RE: ONSITE SEWAGE DISPOSAL SYSTEM
Site Evaluation Approval for Initial and Replacement System
2S2-34-2900
SW Schmeltzer Road; Sherwood

SITE EVALUATION REPORT

SITE EVALUATION FIELD WORKSHEET

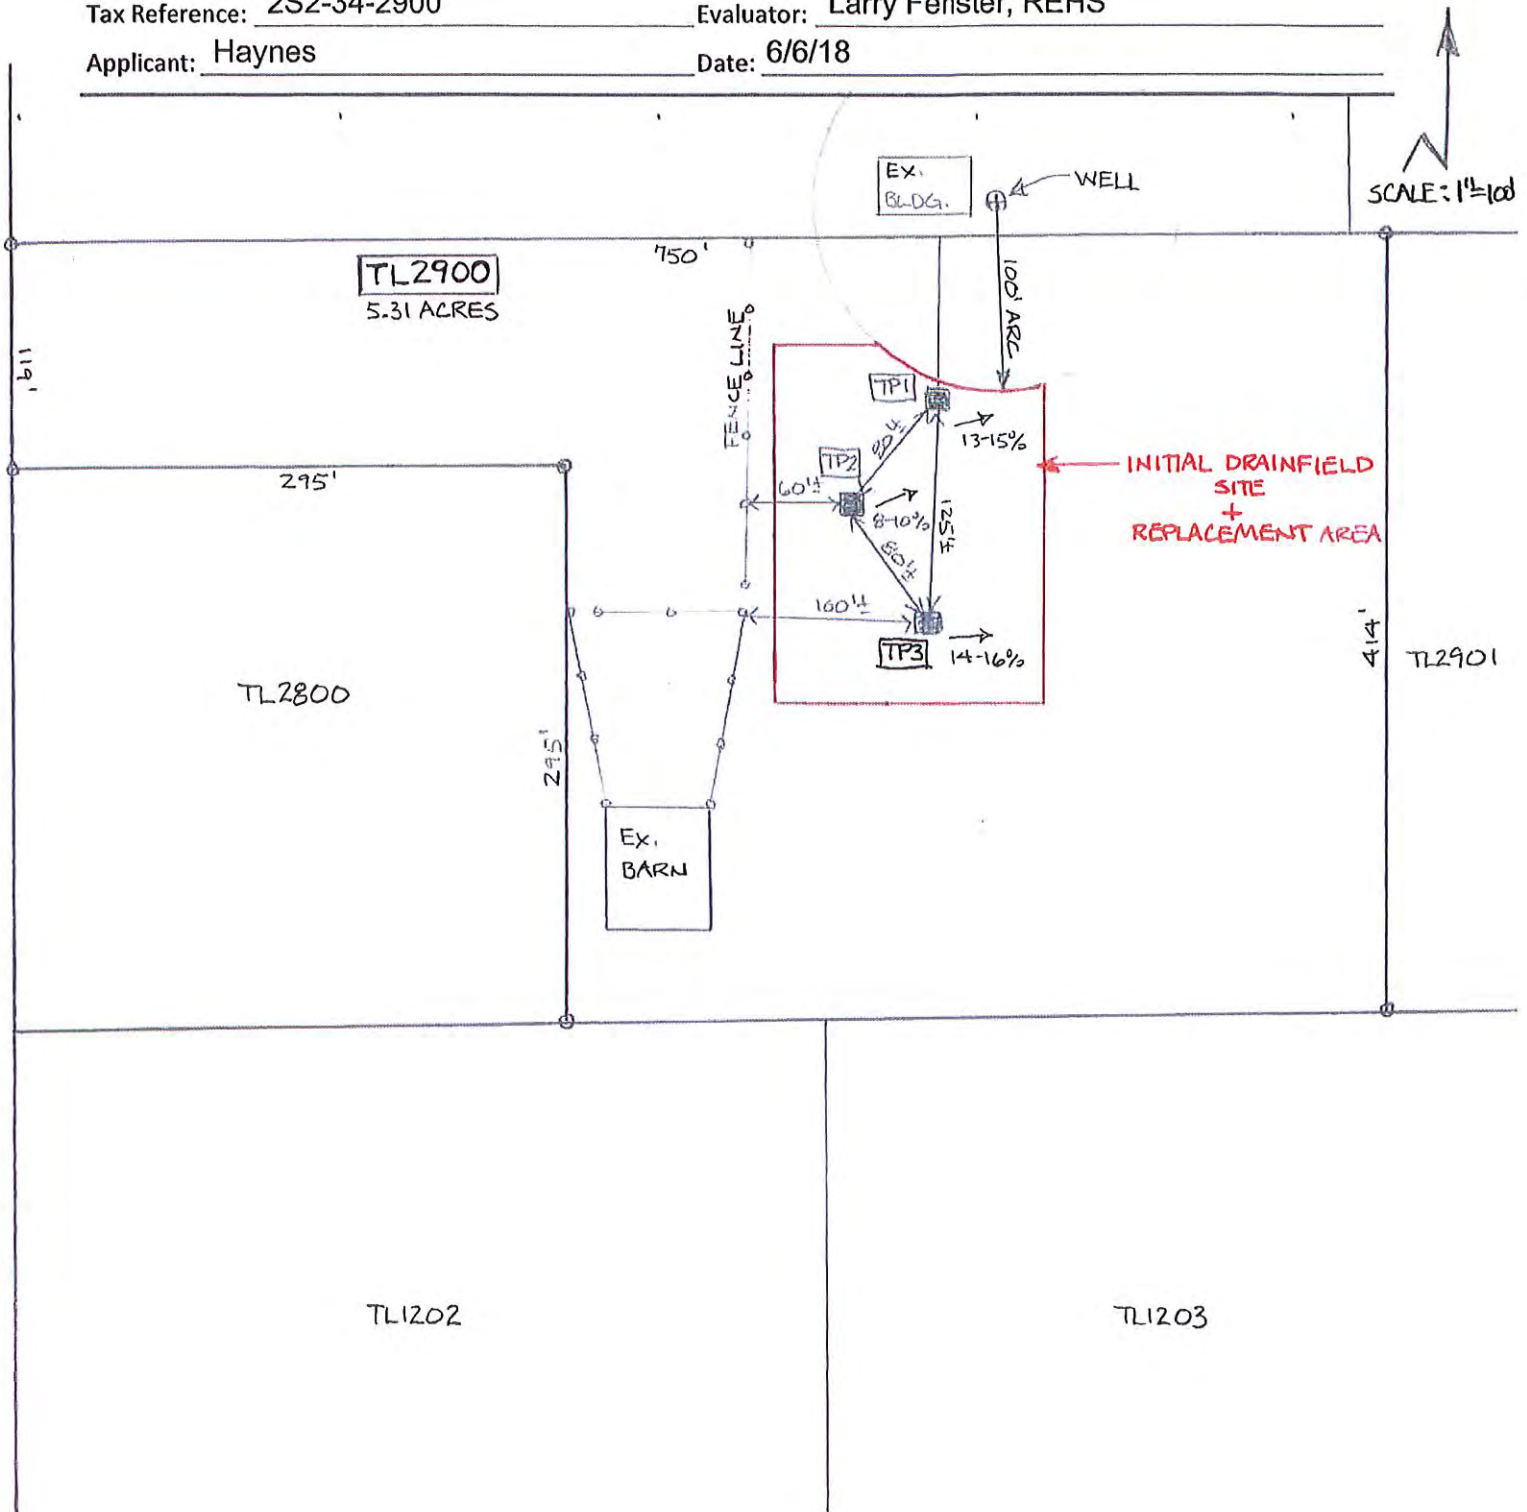
Special Conditions The above noted systems must be installed:

1) Within the approved area noted on back.

2) In accordance with DEQ rules.

Additional Comments and Conditions: Must maintain all DEQ required setbacks including:

- 100' minimum from all wells, springs and year round surface waters.
- 50' minimum from some cuts > 30", escarpments and seasonal surface waters.
- 10' minimum from property lines, easements, utilities and building foundations.

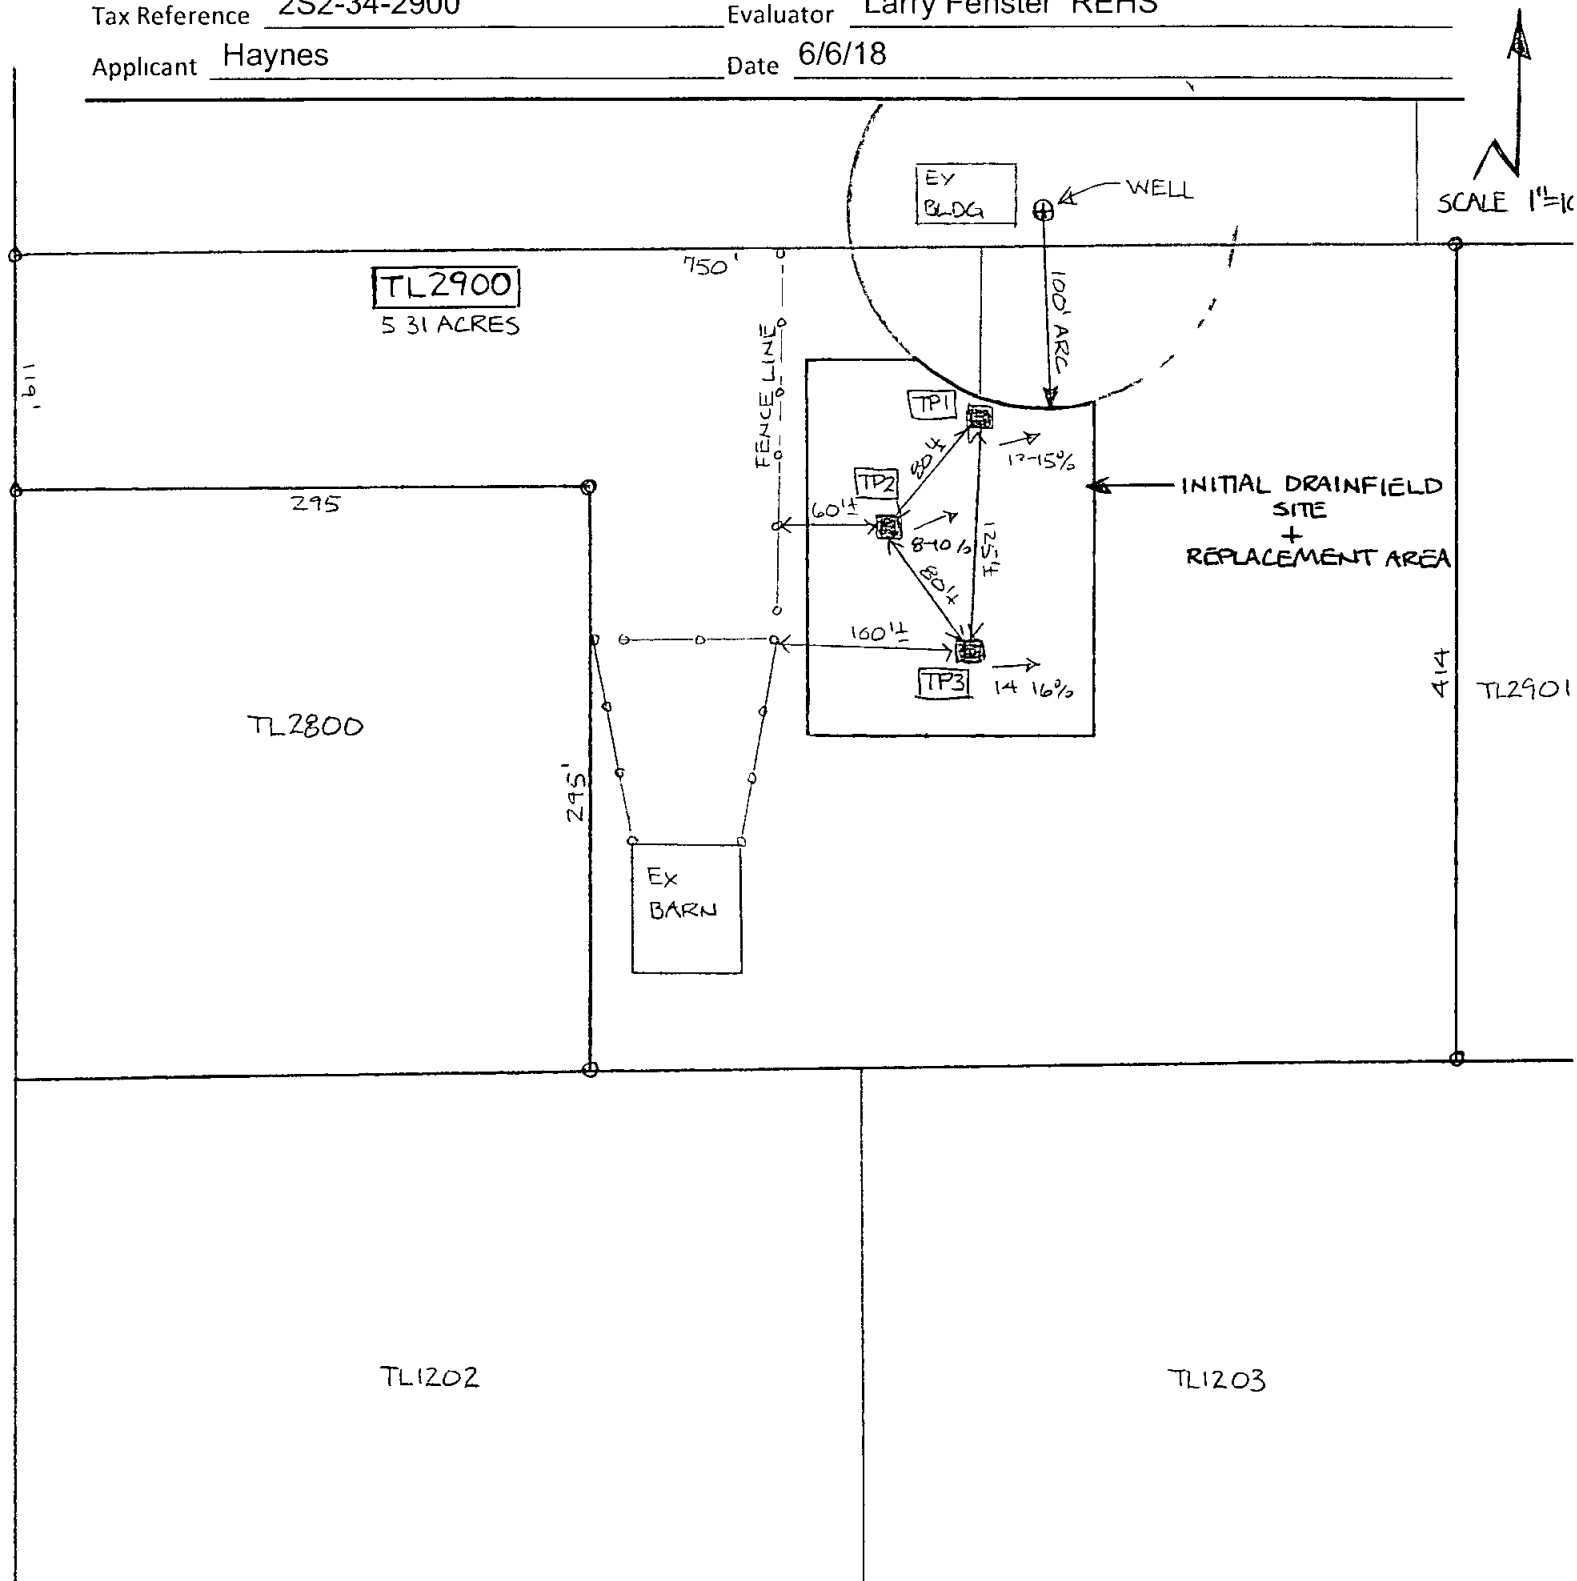
Special Conditions The above noted systems must be installed

1) Within the approved area noted on back

2) In accordance with DEQ rules

Additional Comments and Conditions Must maintain all DEQ required setbacks including

- 100' minimum from all wells springs and year round surface waters
- 50' minimum from some cuts > 30", escarpments and seasonal surface waters
- 10 minimum from property lines easements, utilities and building foundations

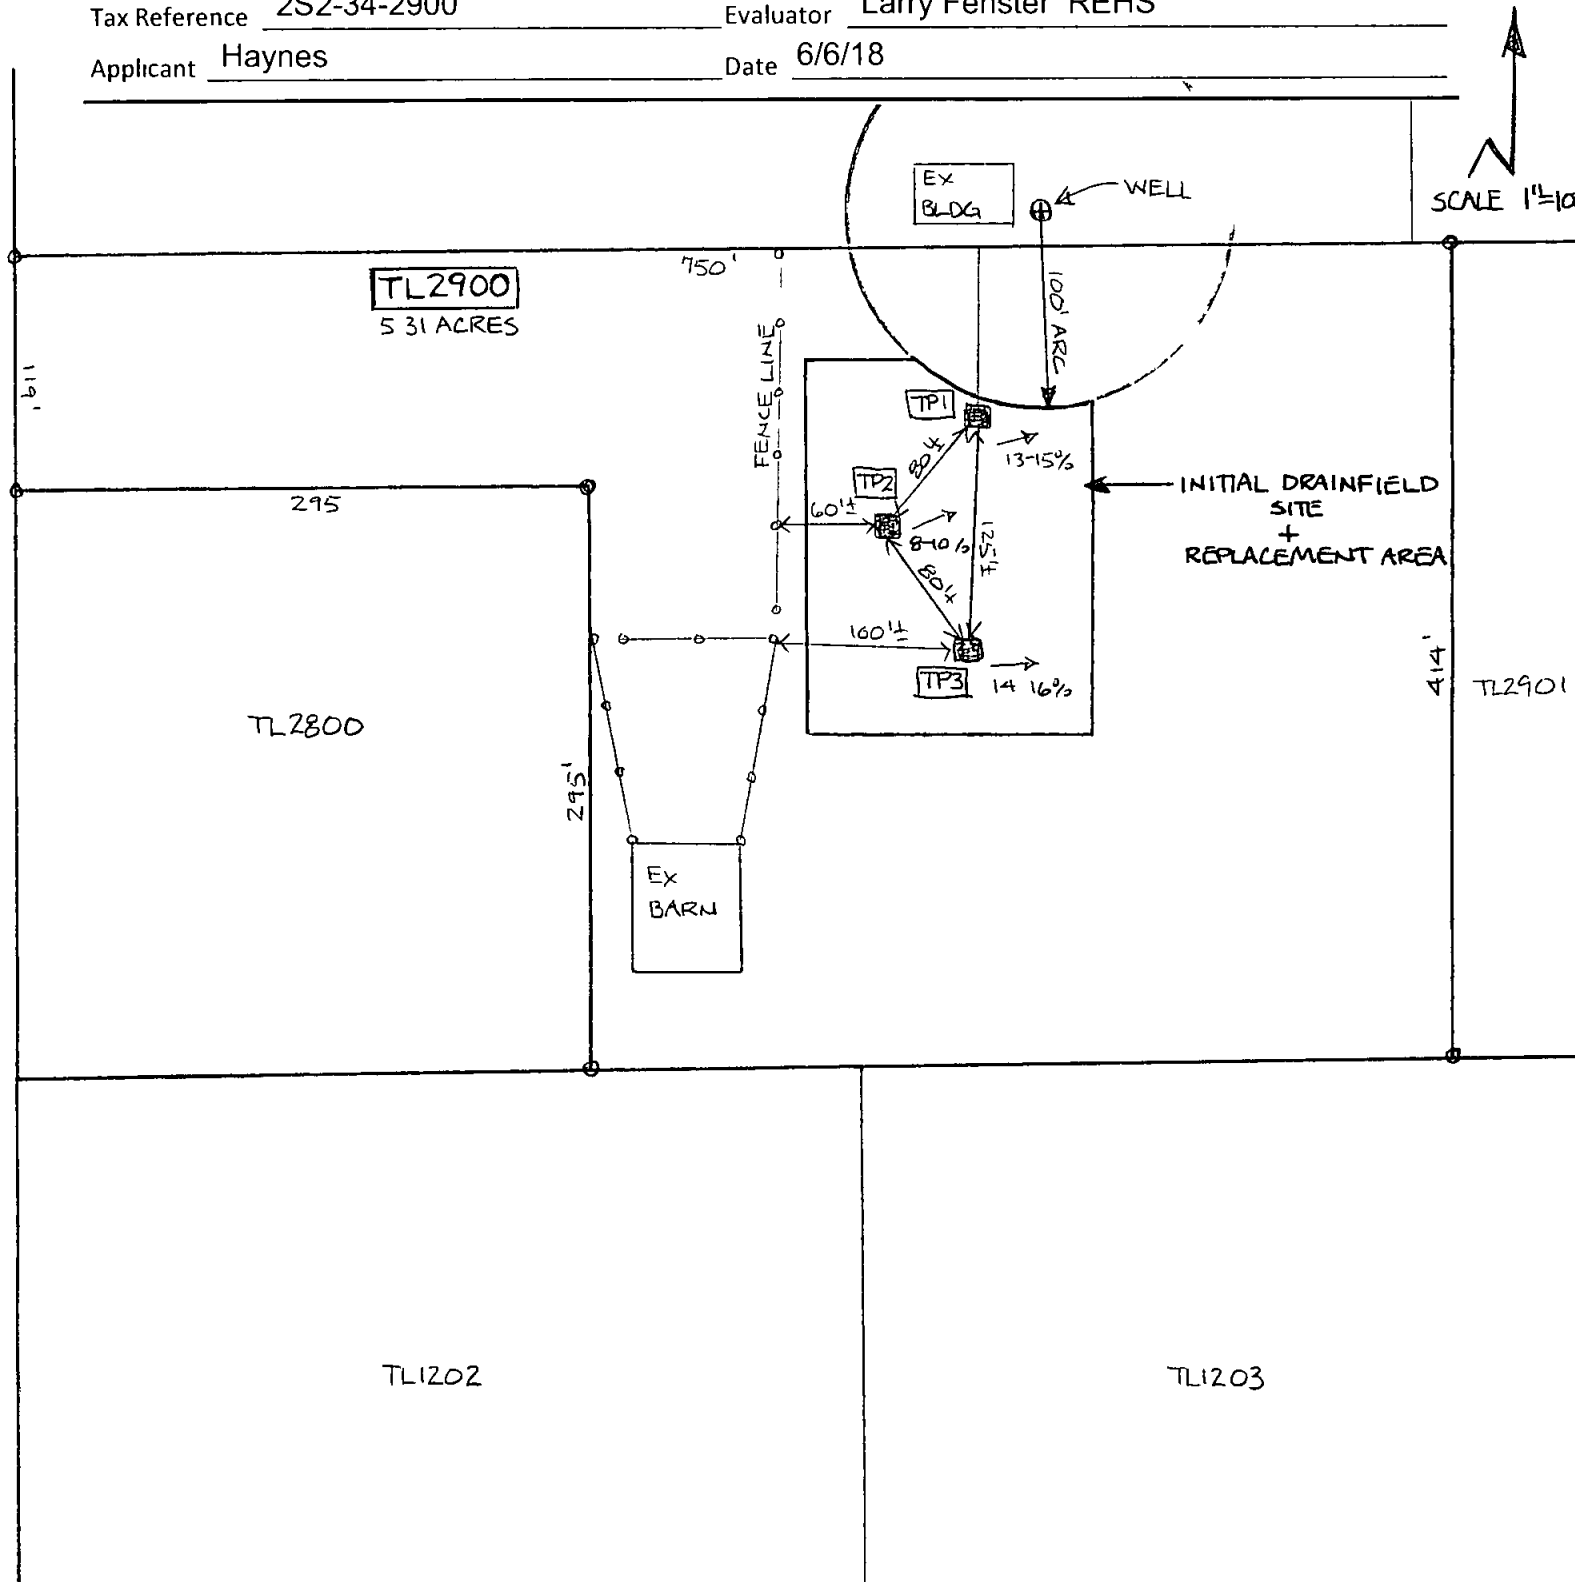
Special Conditions The above noted systems must be installed

1) Within the approved area noted on back

2) In accordance with DEQ rules

Additional Comments and Conditions Must maintain all DEQ required setbacks including

- 100' minimum from all wells springs and year round surface waters

- 50' minimum from some cuts > 30" escarpments and seasonal surface waters

- 10' minimum from property lines, easements utilities and building foundations
